**Addendum No. 1**  
**February 17, 2025**

Project: Lincoln High School Auditorium Renovation  
Sioux Falls, South Dakota  
Project #3021

Architect: Architecture Incorporated

**QT5.01**

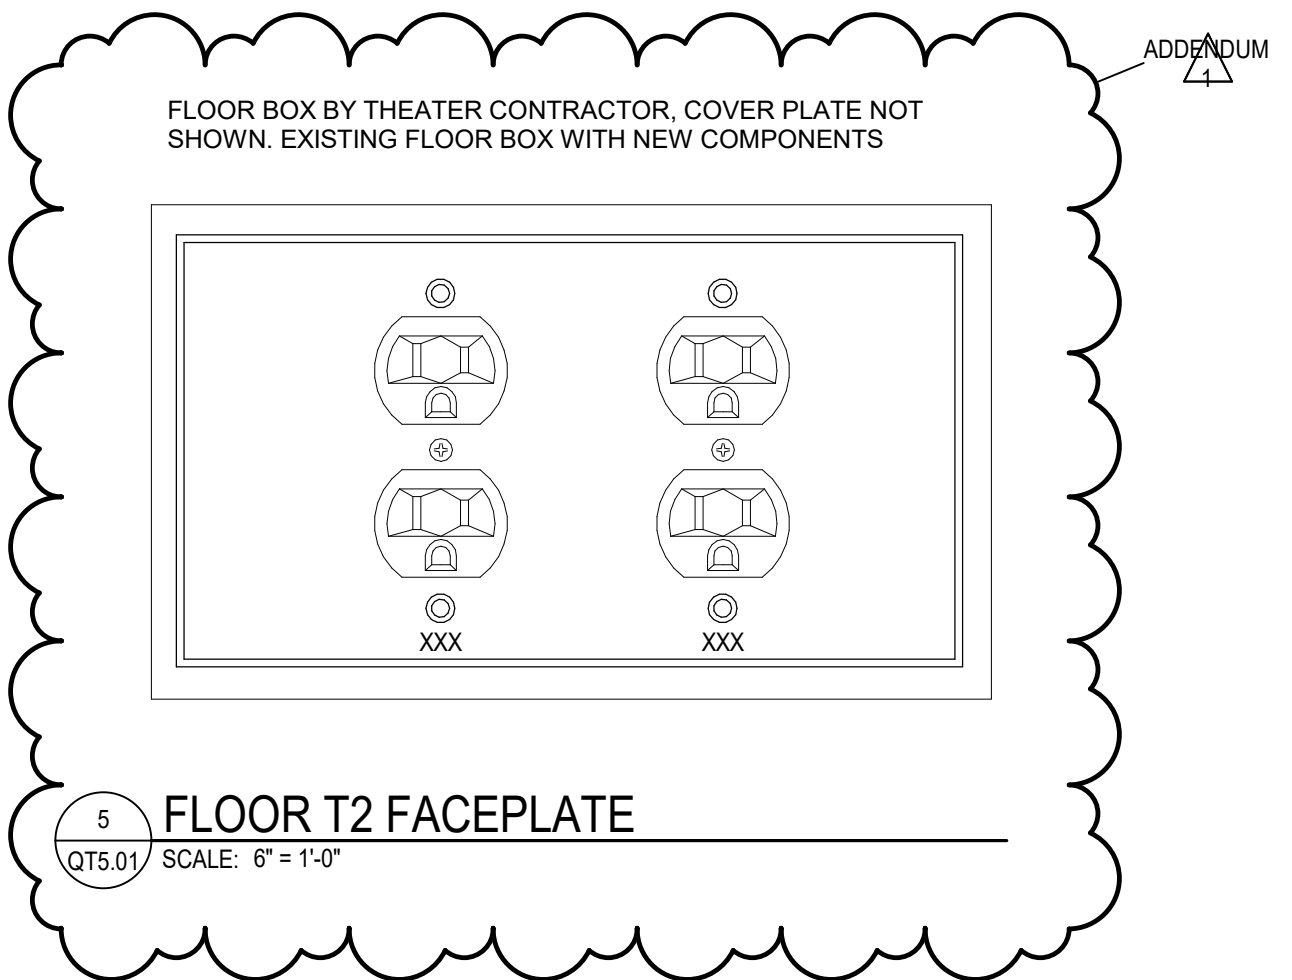
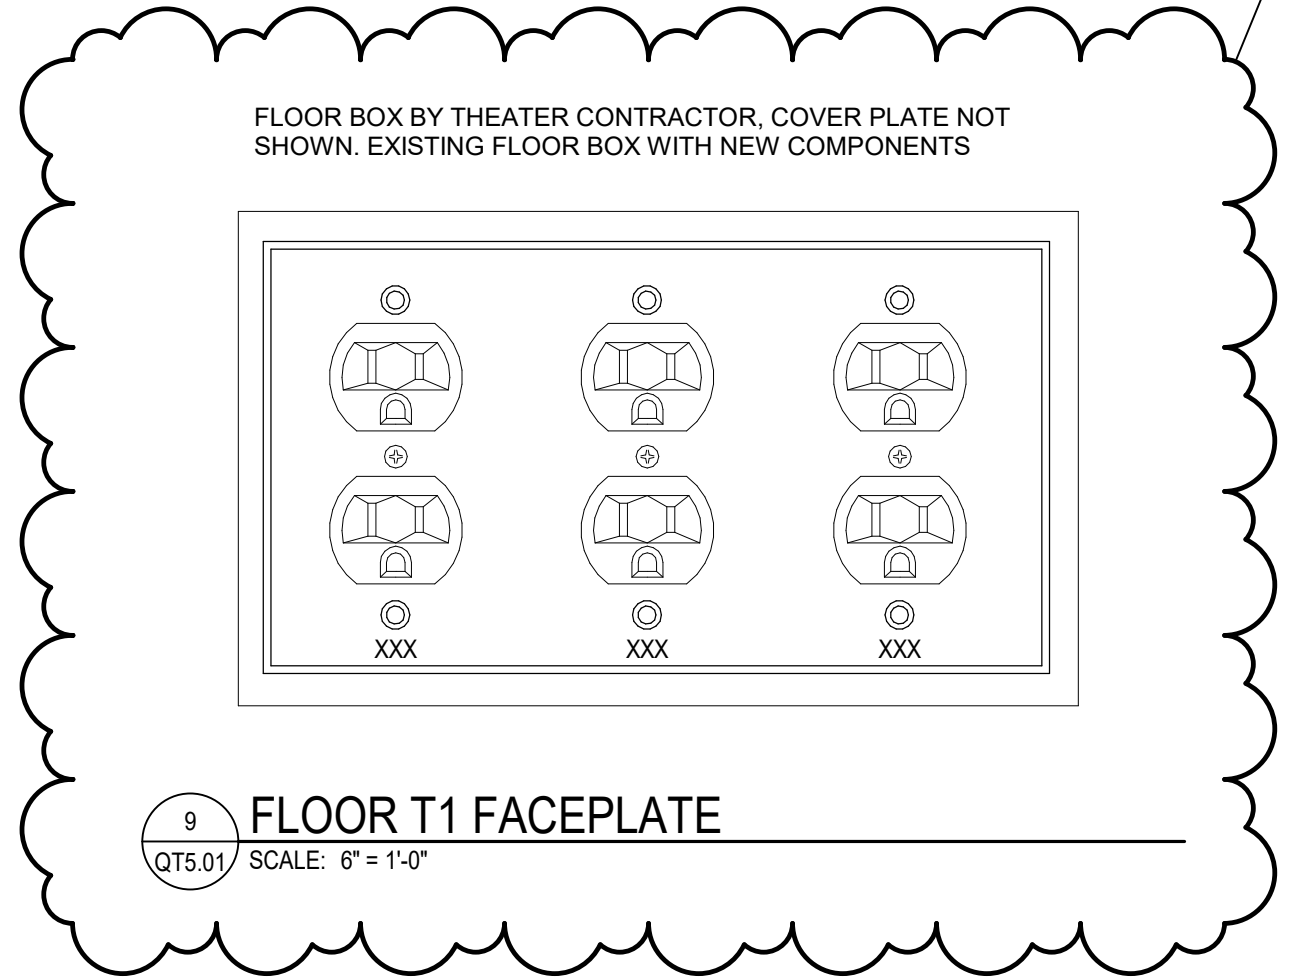
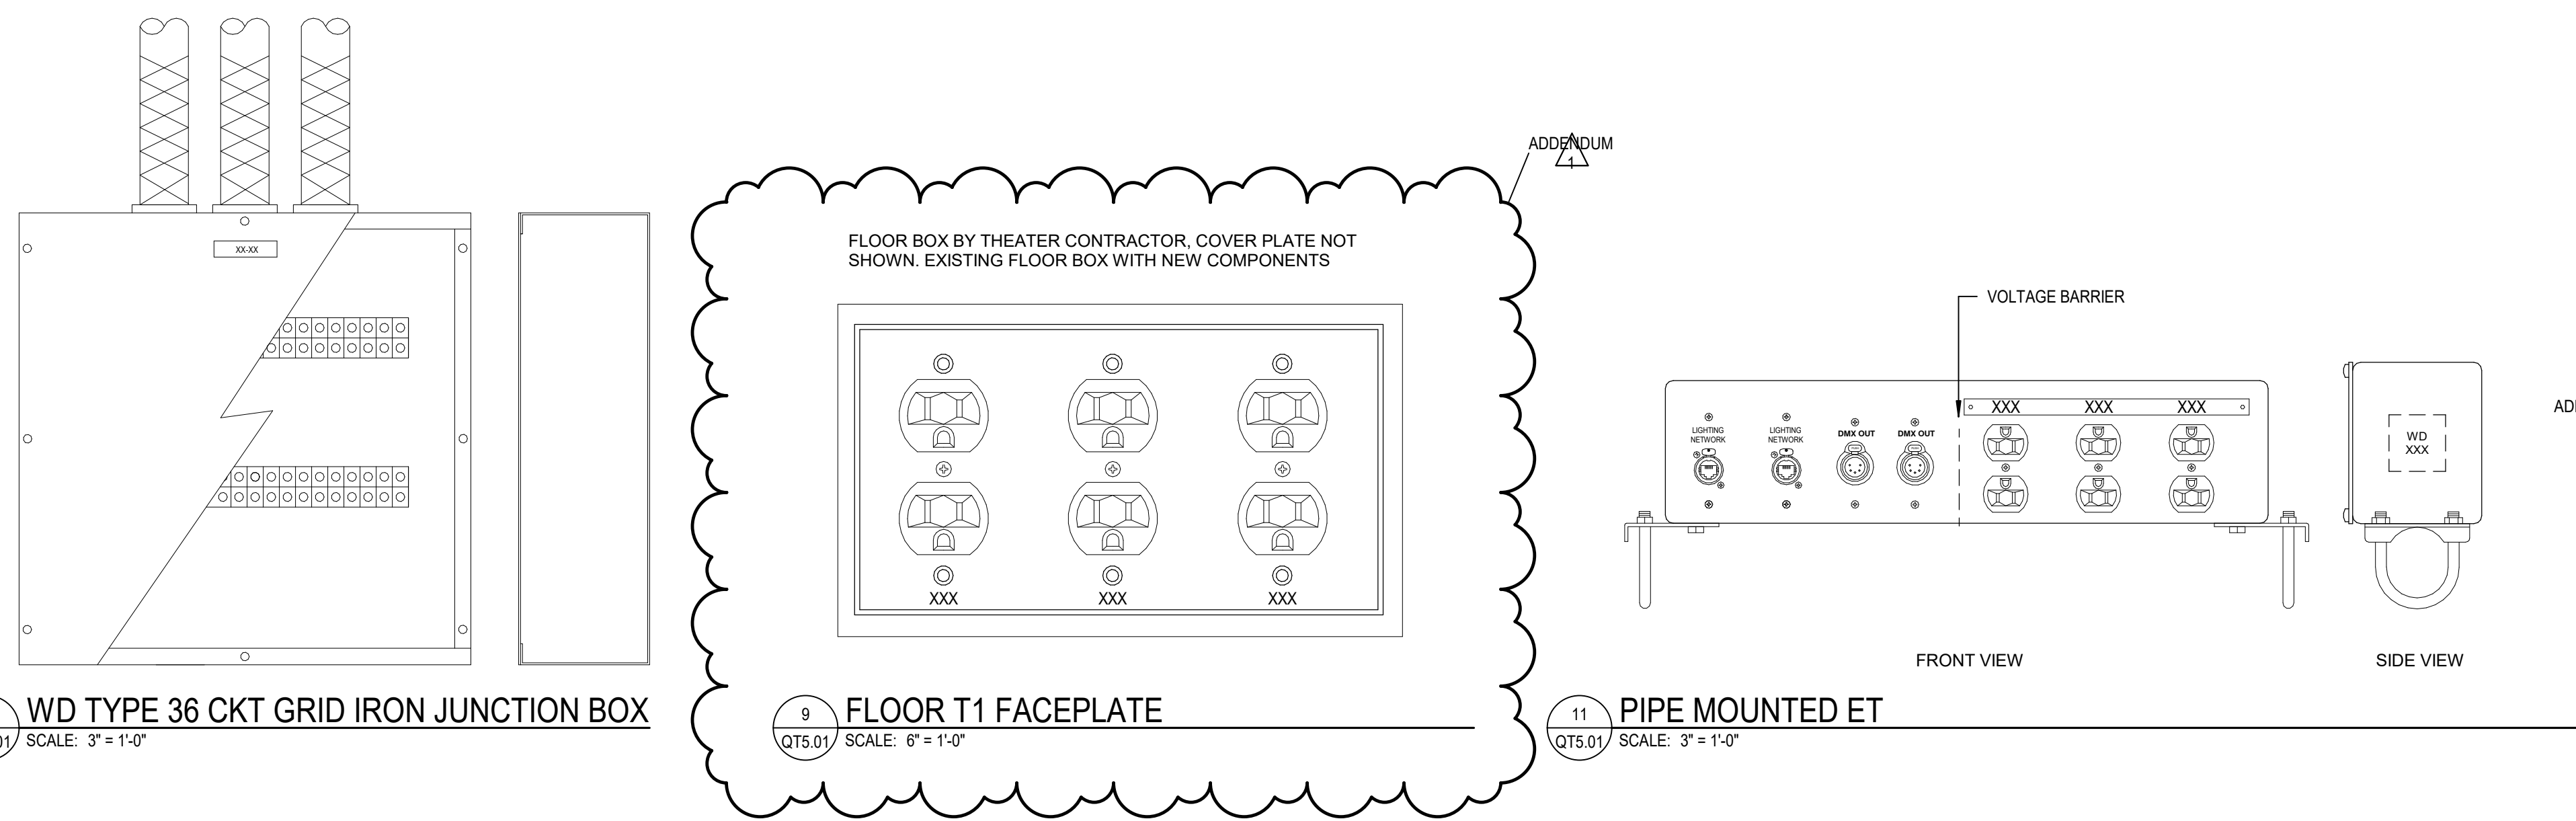
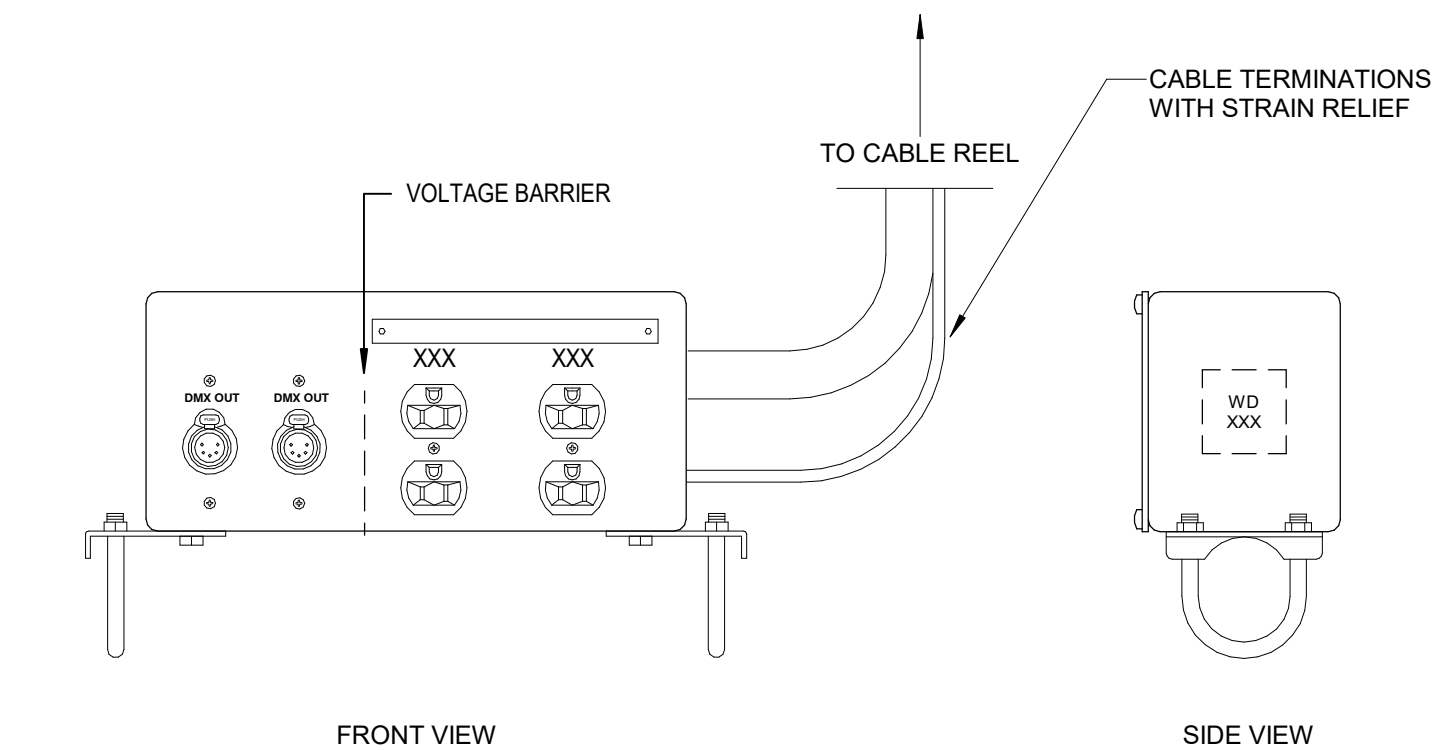
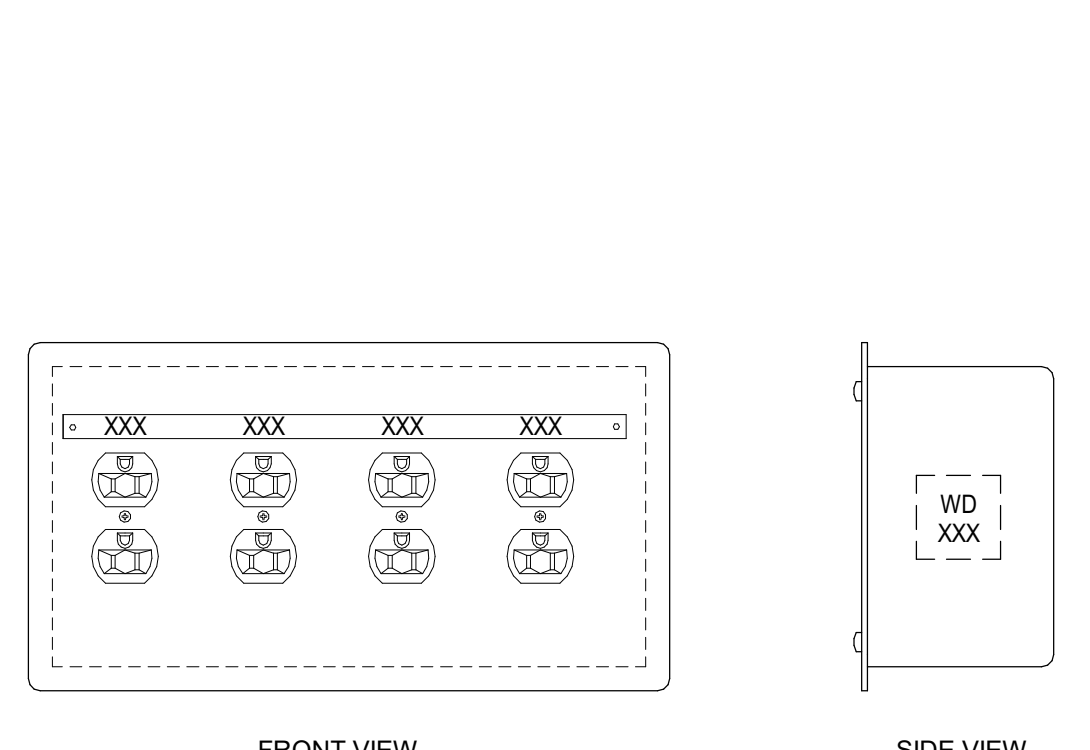
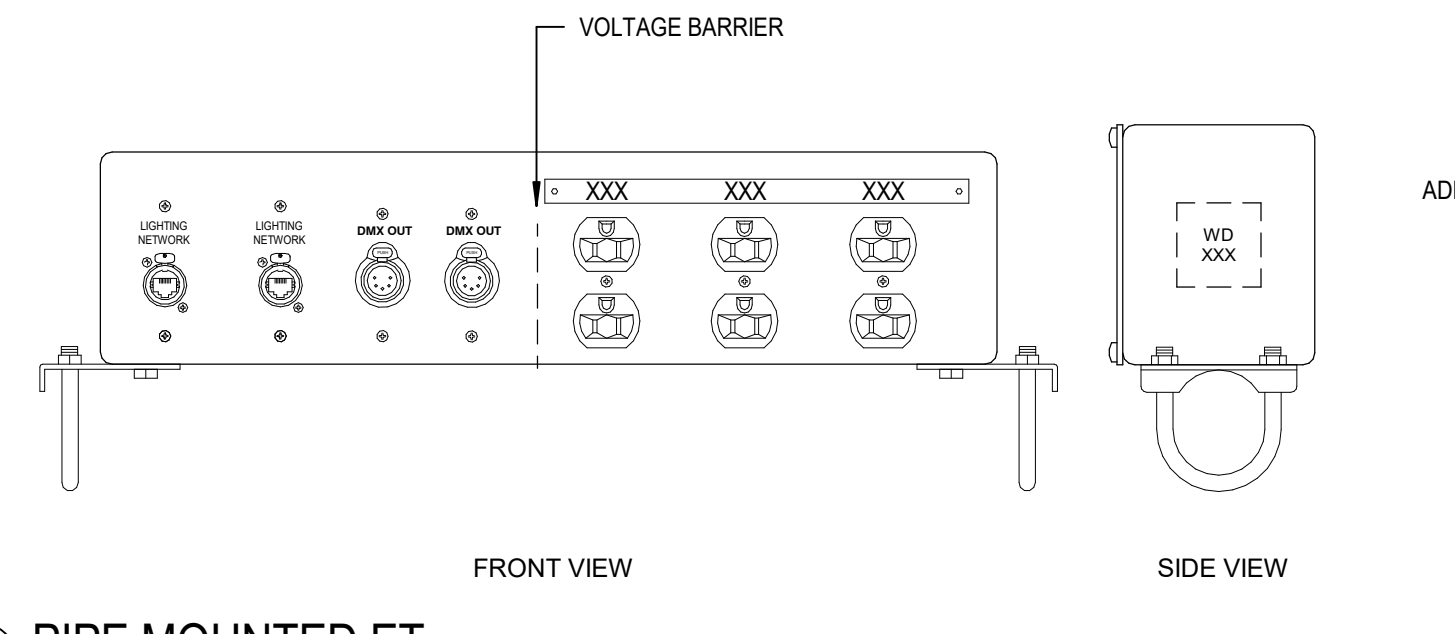
5) SHEET QT5.01 – THEATRICAL WIRING DEVICE DETAILS & SCHEDULE

- c. Revise detail 9, FLOOR T1 FACEPLACE
- d. Add detail 5, FLOOR T2 FACEPLATE
- e. THEATRICAL WIRING DEVICE SCHEDULE
  - 1. Revise devices WD09 - WD12 details and descriptions per attached sheet.
- f. THEATRICAL ELECTRICAL EQUIPMENT SCHEDULE
  - 1. Revise device location per attached sheet.
